Serial No. 1118

January 29, 1985

RESPONSES TO NRC QUESTIONS DURING TELEPHONE CONVERSATION  
IN NOVEMBER 1984

GROUNDWATER MIGRATION ANALYSIS FOR THE ON-SITE DISPOSAL  
OF LOW-LEVEL RADIOACTIVELY CONTAMINATED RESIN AT  
THE DAVIS-BESSE NUCLEAR POWER STATION

PROPOSED  
DISPOSAL  
AREA

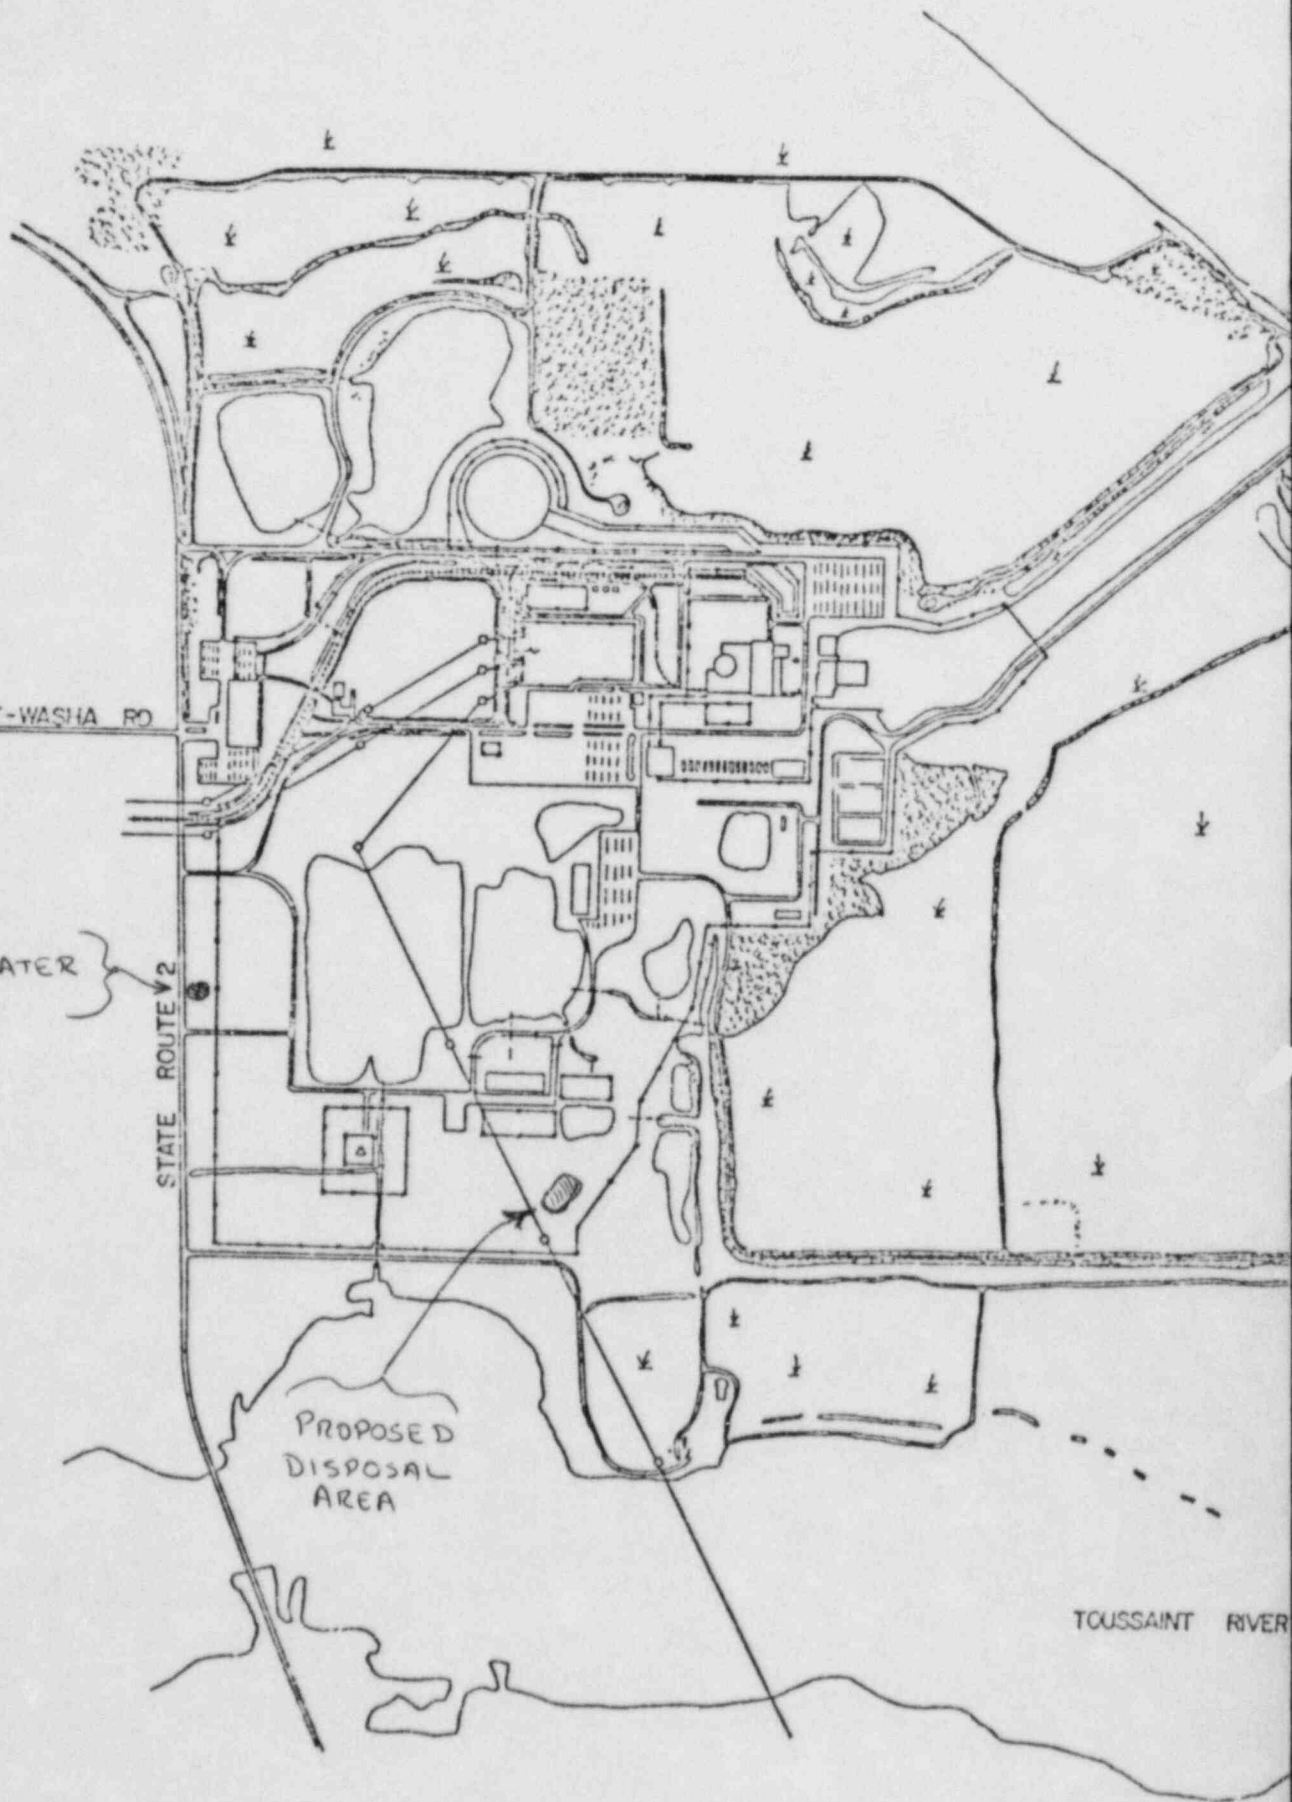
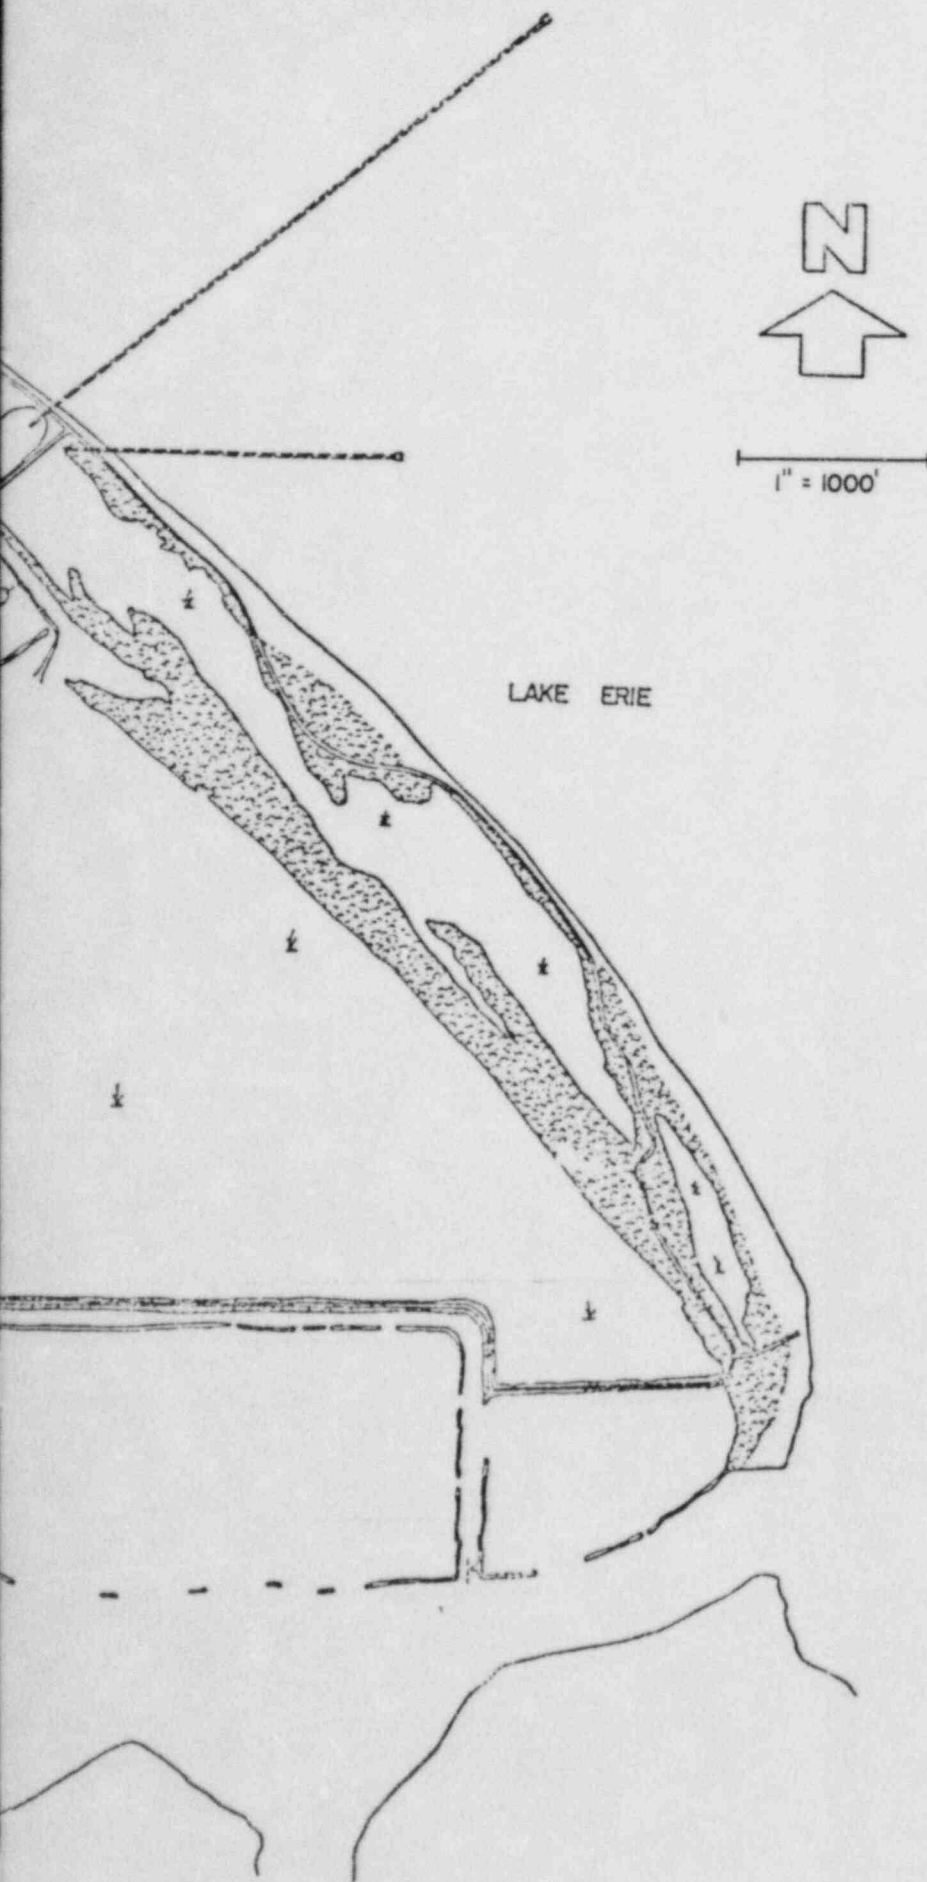
- Question 3: Provide a map indicating the location of the burial site and the worst location for the nearest well.
- Response: Attachment No. 3 indicates the proposed disposal area and the nearest groundwater well to the disposal area. The water from the well is not used for drinking water. Samples are collected quarterly and analyzed for radioactivity as part of the environmental radiological monitoring program.
